Long-Term Monitoring Network Optimization Evaluation

Operable Unit 2 Bunker Hill Mining and Metallurgical Complex Superfund Site Idaho

January 2006

EPA 542-R-06-005
December 2006
www.epa.gov

FIGURE 2.1
OU2 SITE FEATURES

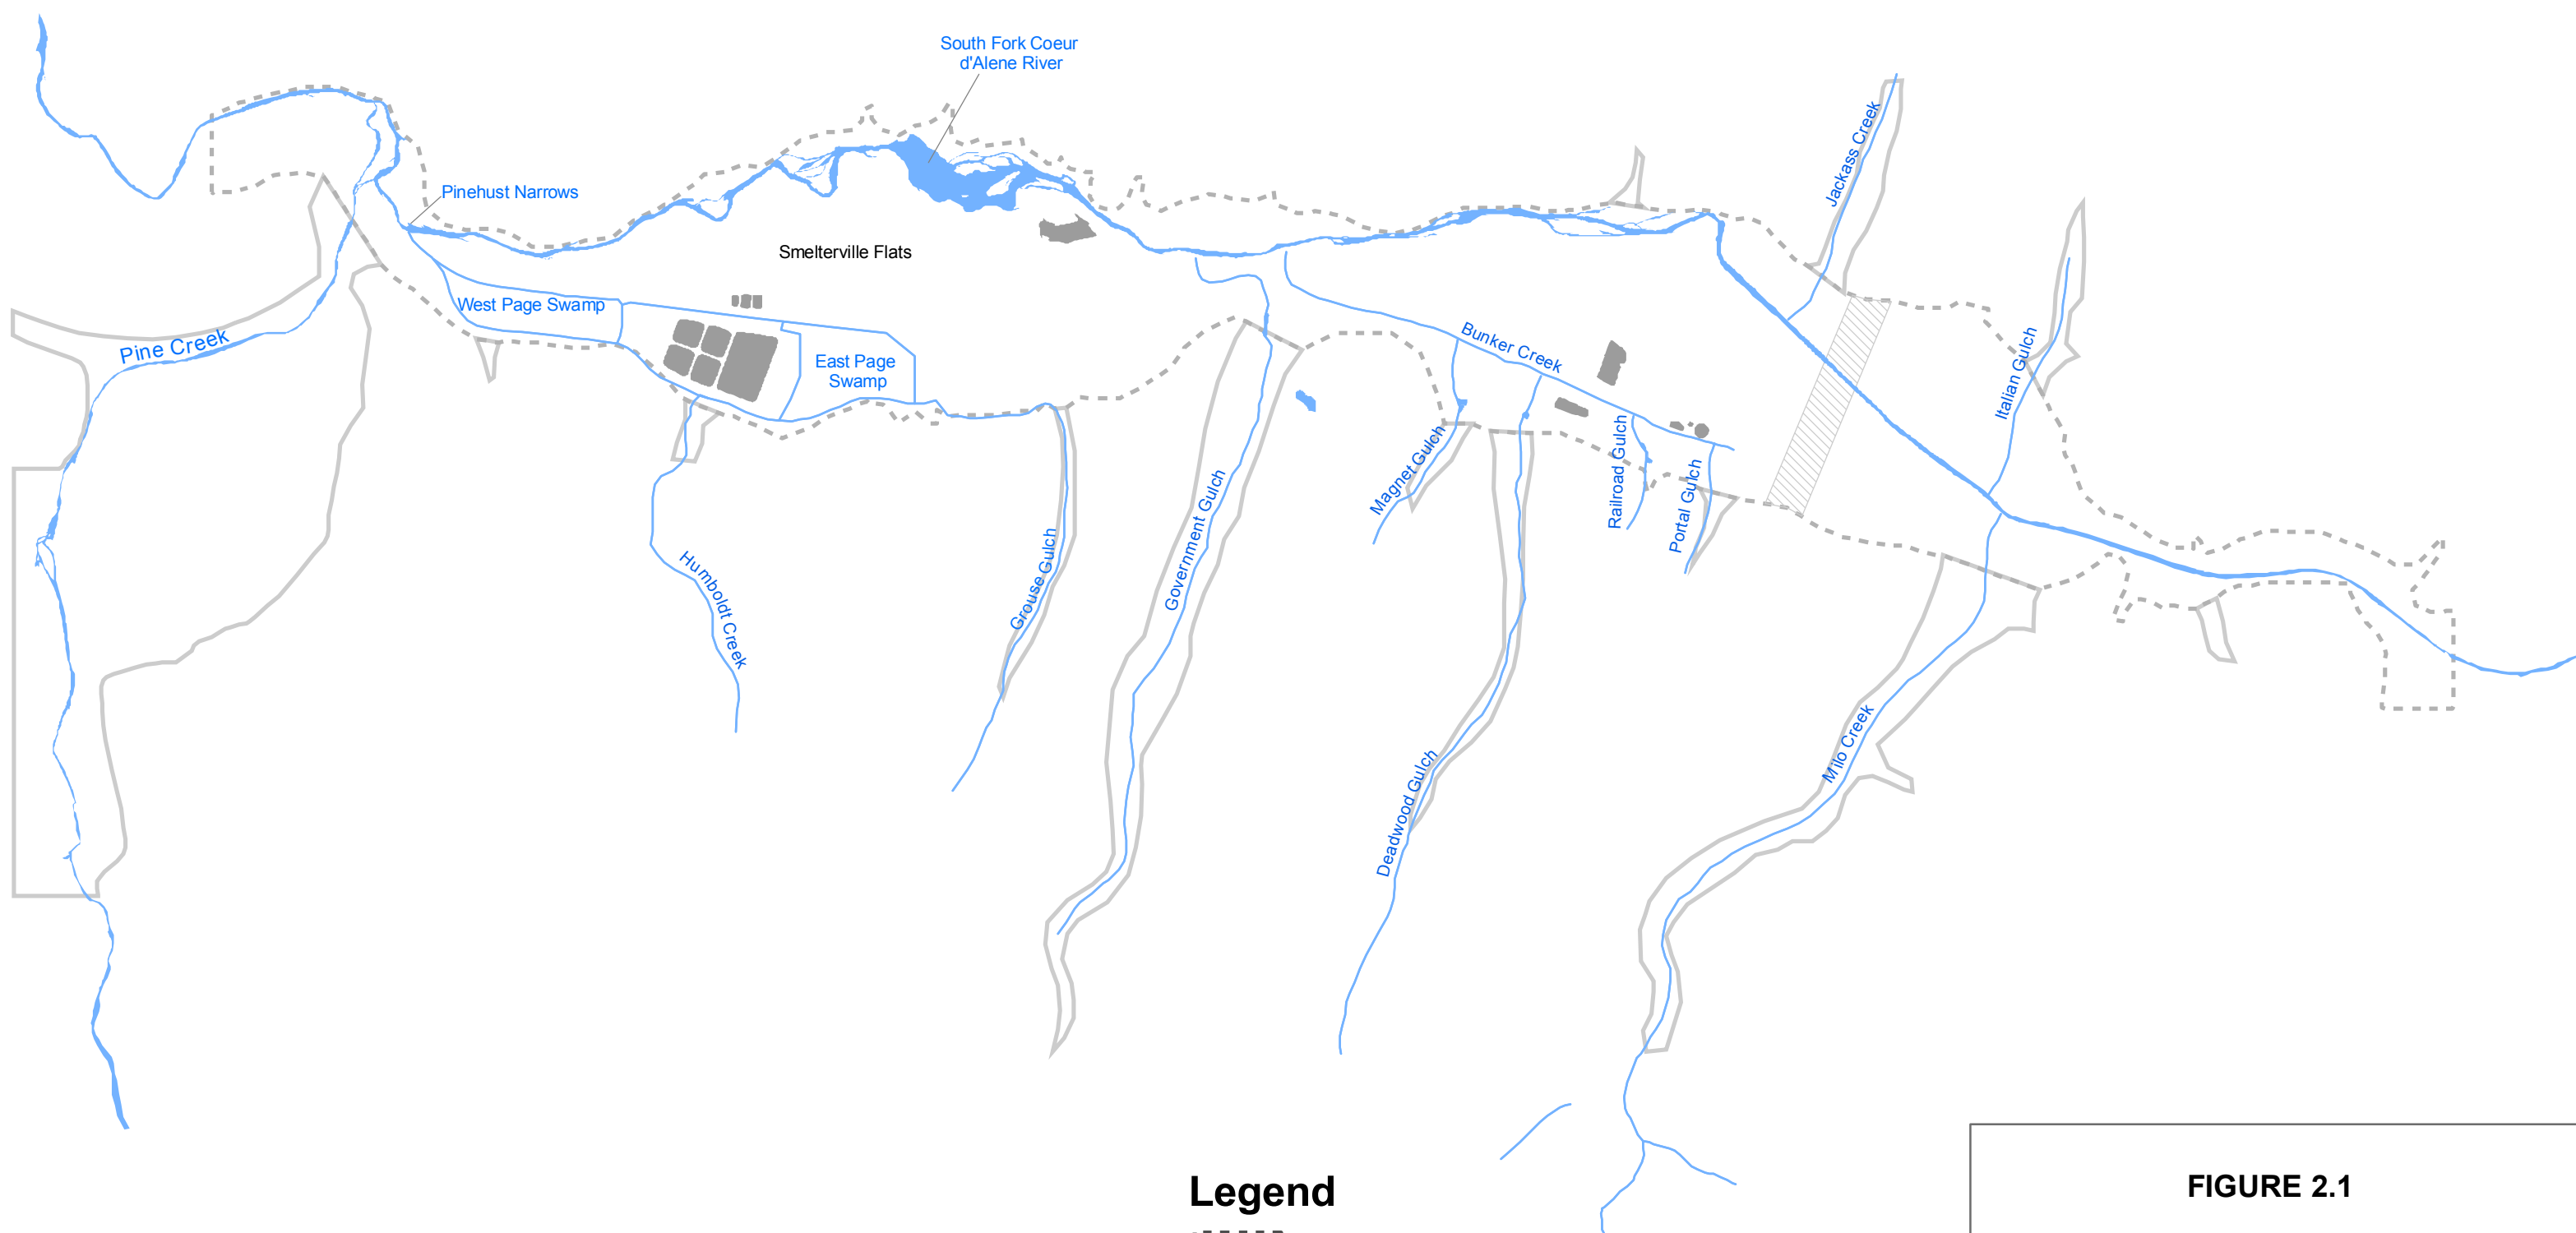
Item No.	Section/Page	Line(s)	Comment	Response
1.	Title		It would alleviate a potential source of confusion to add Operable Unit 2 to the title.	Done.
2.	Figure 2.1		The confining unit box shown in this figure and others within the report should be identified as the approximate eastern extent of the confining unit.	Done.

FIGURE 3.3

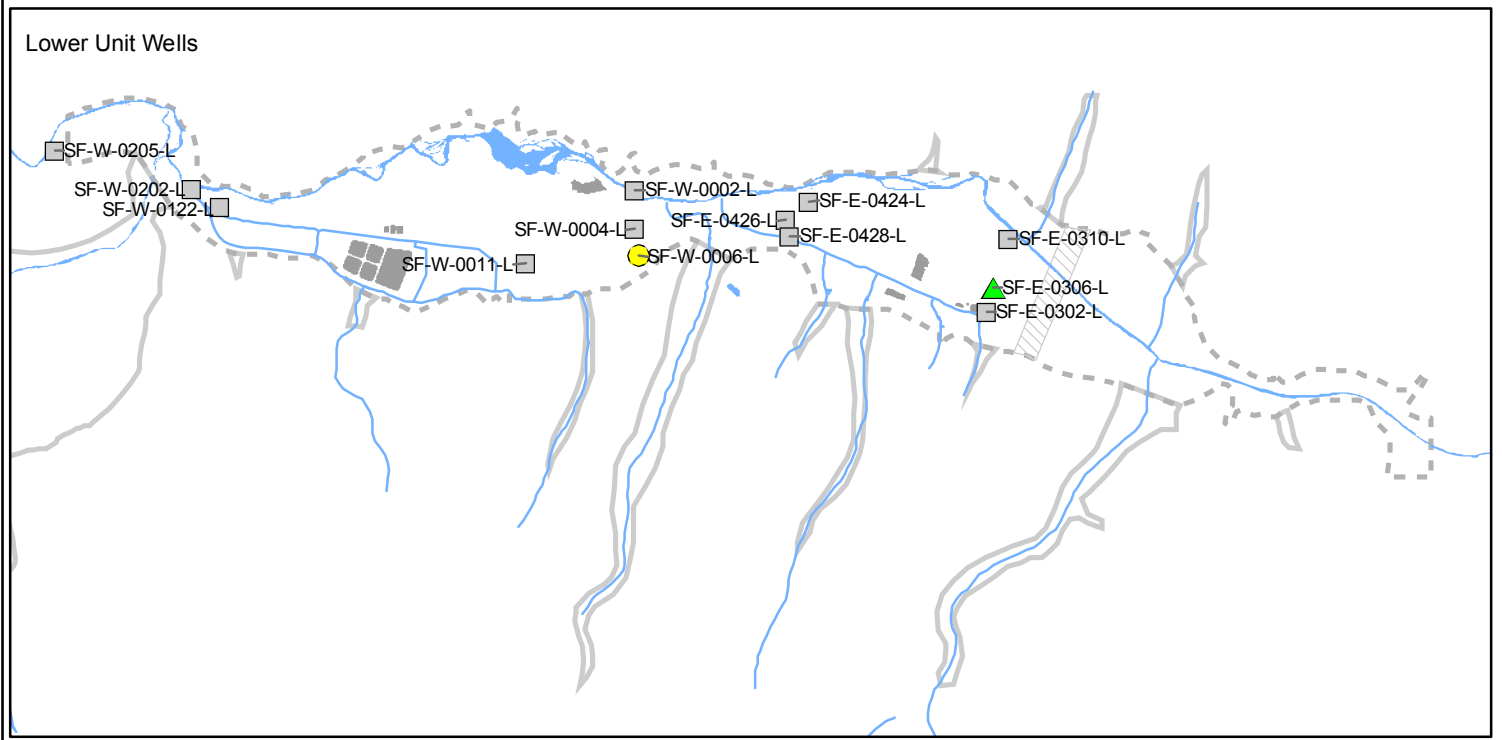
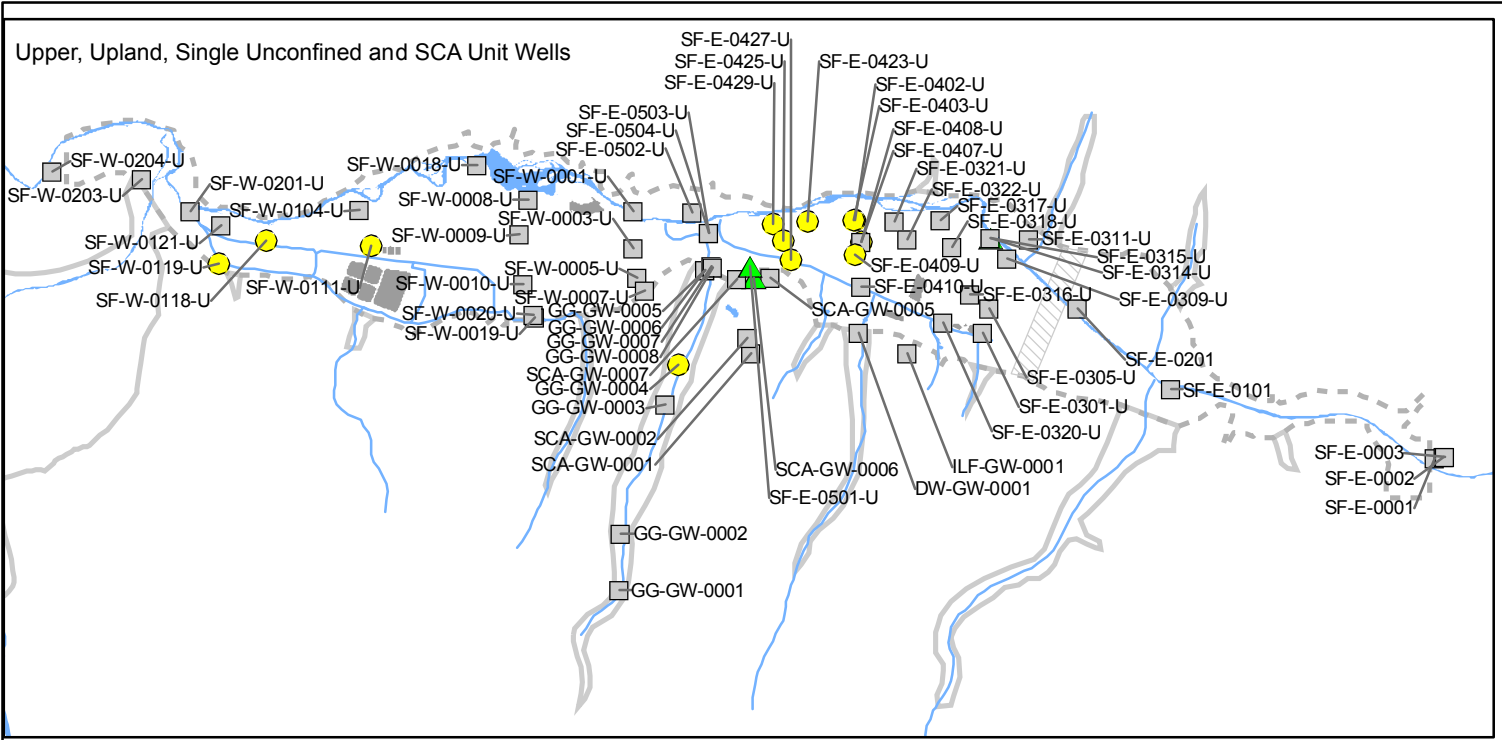
2.	Page 3-12	Figure 3.3	Please use different symbols in addition to colors in case people only have a black-and-white copy.	Symbols modified in maps to allow for differentiation in black and white.

Item No.	Comment	Response
1.	The graphics should be readily copied in black and white. Most of document is already copiable in black/white – but a few figures need some symbol adjustments (e.g., Fig. 3.3 and 3.4).	Figures adjusted to display symbology in black and white.

FIGURE 3.7

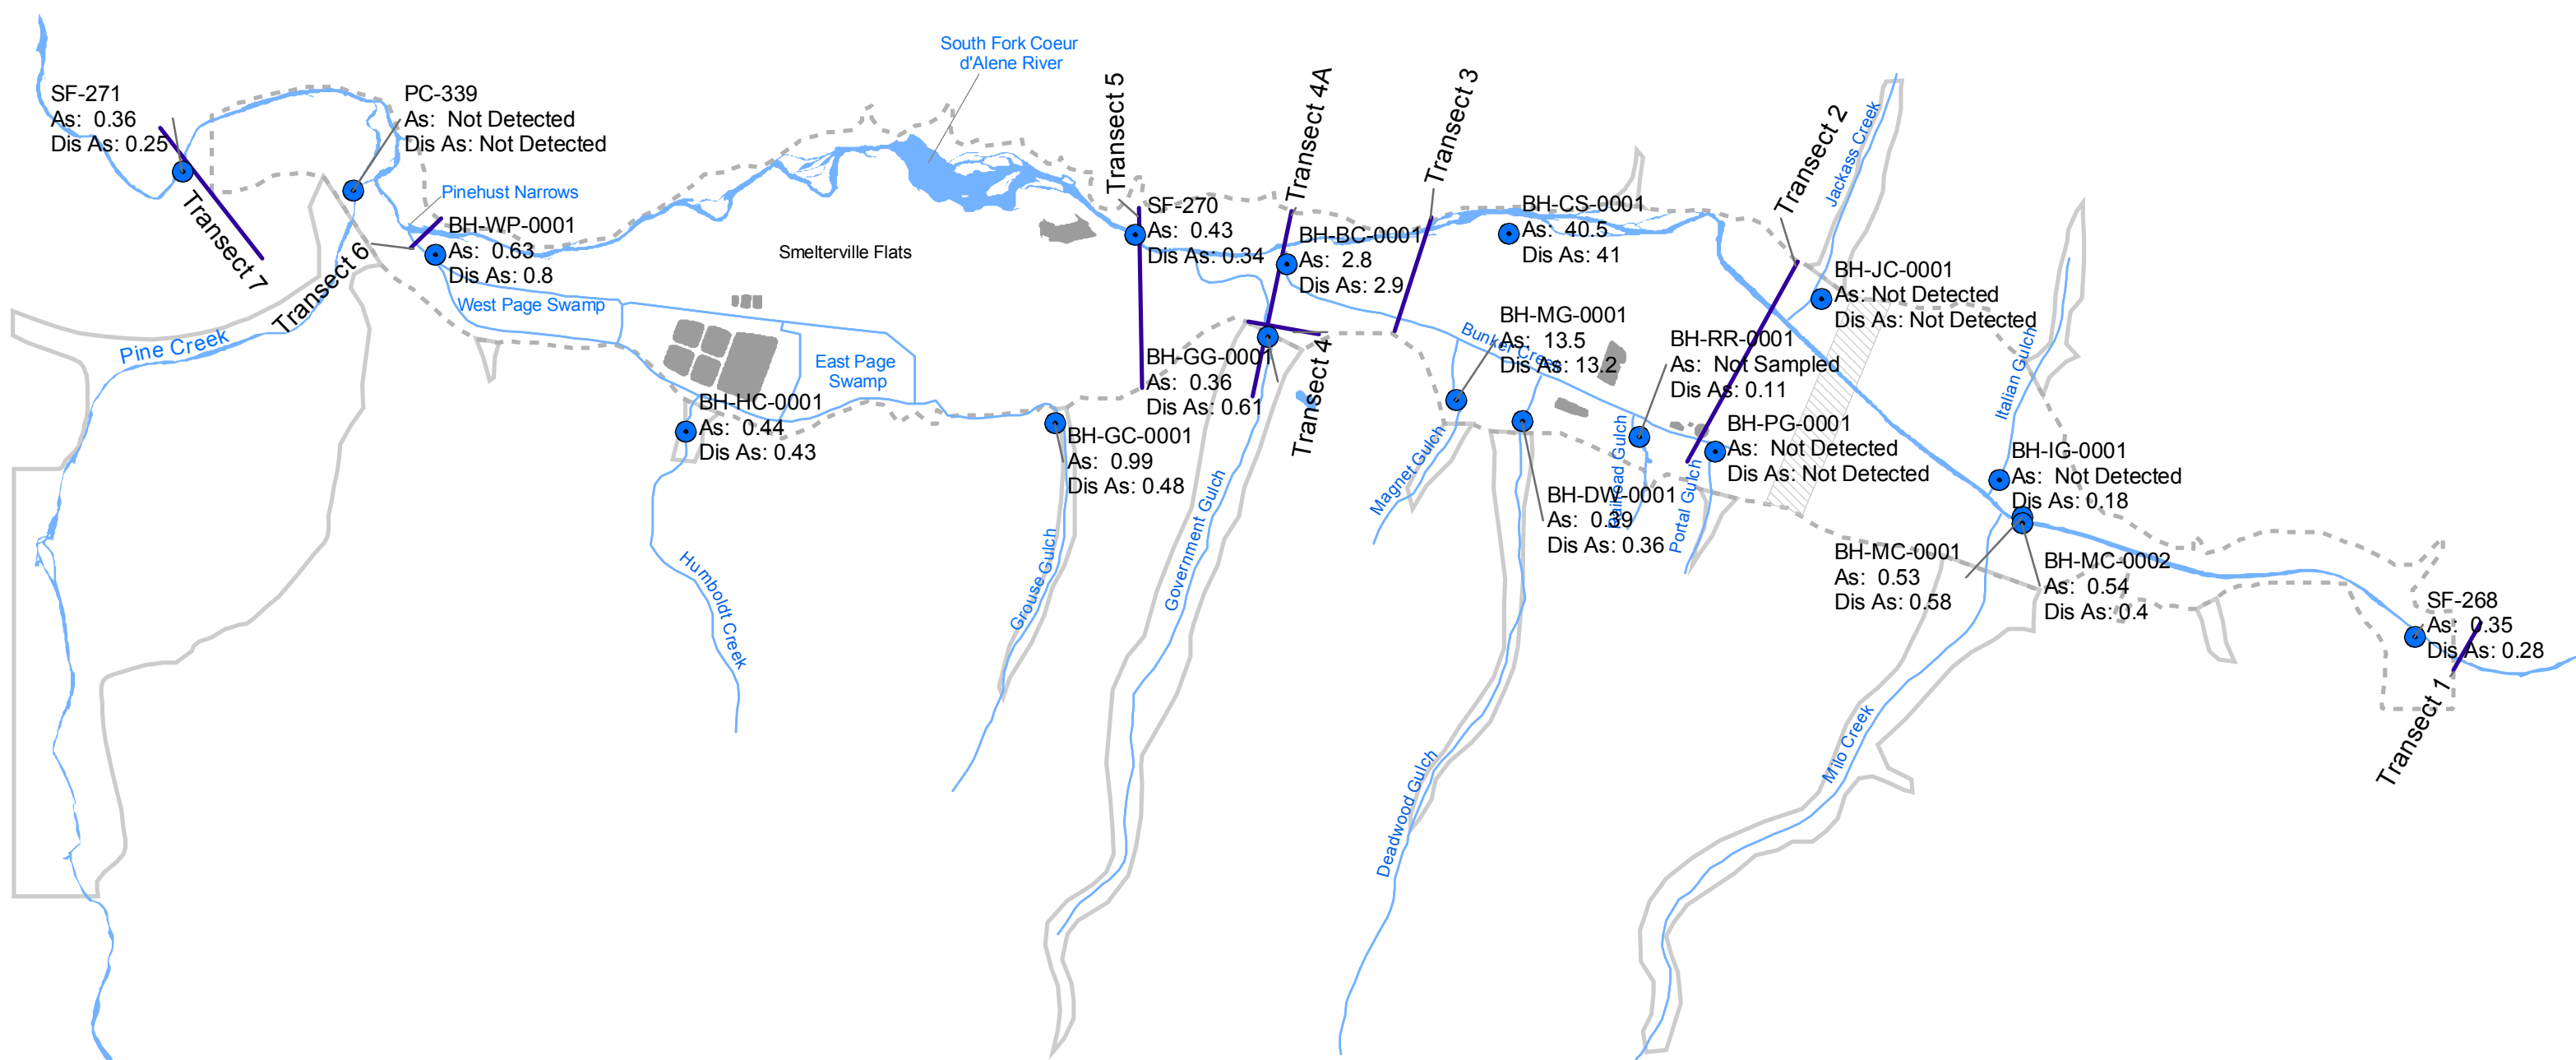
3.	Page 3-19	Figure 3.7 and subsequent figures	Some of the posted values are the same for several sampling points. Please verify the values. Are these detection limits?	The figures were revised to display non-detects as "ND" and to post the correct COC data (corresponding to Table 3.6).

FIGURE 5.4
TEMPORAL TREND DECISION RATIONALE FLOWCHART
LONG-TERM MONITORING NETWORK OPTIMIZATION
BUNKER HILL MINING AND METALLURGICAL COMPLEX SUPERFUND SITE

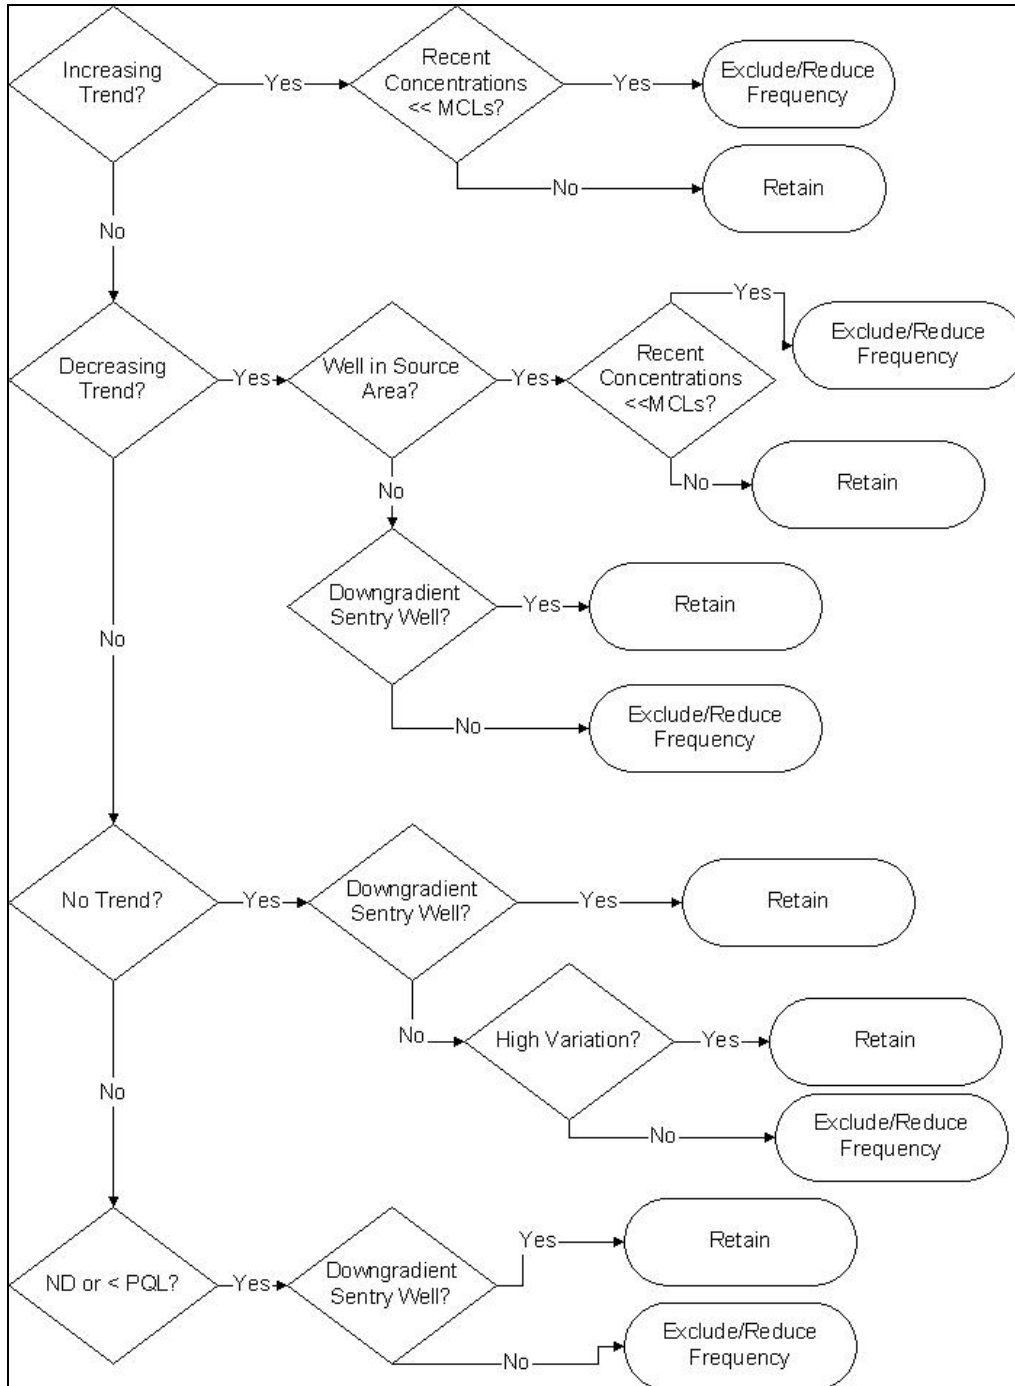
2.	Figure 5.4	What is the criterion for the box labeled “high variation”?	High variation = coefficient of variation > 1 (consistent with MAROS). Footnote added to table and explanation added to text.

41.	Figure 5.4		Interesting but does not fit the OU2 area because metal sources exist over most of the area.	Although the Bunker Hill site does not fit the typical mold of a groundwater monitoring site, the temporal trend flow chart still is applicable because (as indicated in the comment) most wells were classified as “source wells” (as shown in Table 5.1) and temporal recommendations were made on that basis.

FIGURE 7.2
COMBINED EVALUATION SUMMARY DECISION LOGIC
LONG-TERM MONITORING NETWORK OPTIMIZATION
BUNKER HILL MINING AND METALLURGICAL COMPLEX

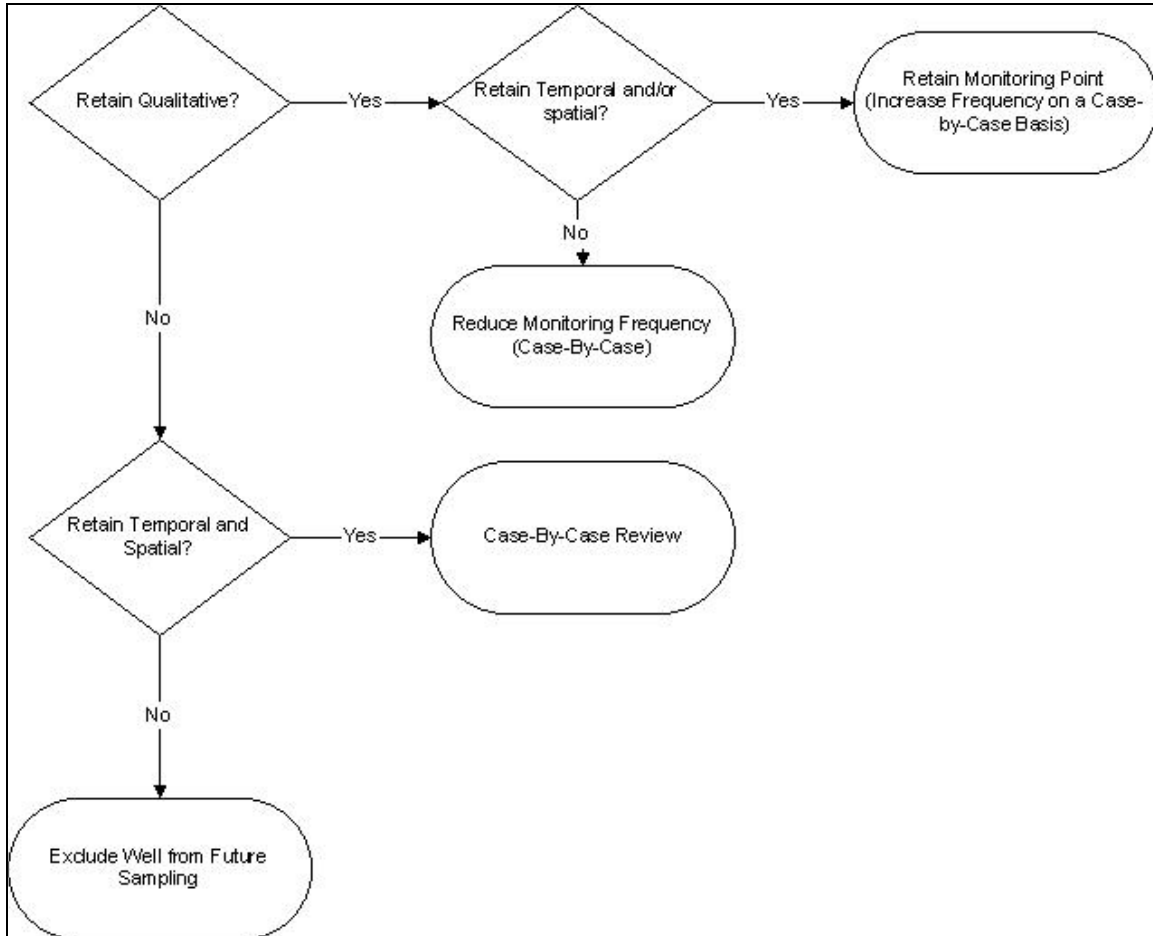
11.	Page 7-2	Table 7.1	Please show the recommended additional wells in this table.	New wells added to summary table.
12.	Page 7-6	Figure 7.2	Again, please indicate the potential to increase sampling frequency for increasing trends in downgradient wells if the current frequency is not adequate.	Increase frequency option added to flow chart.
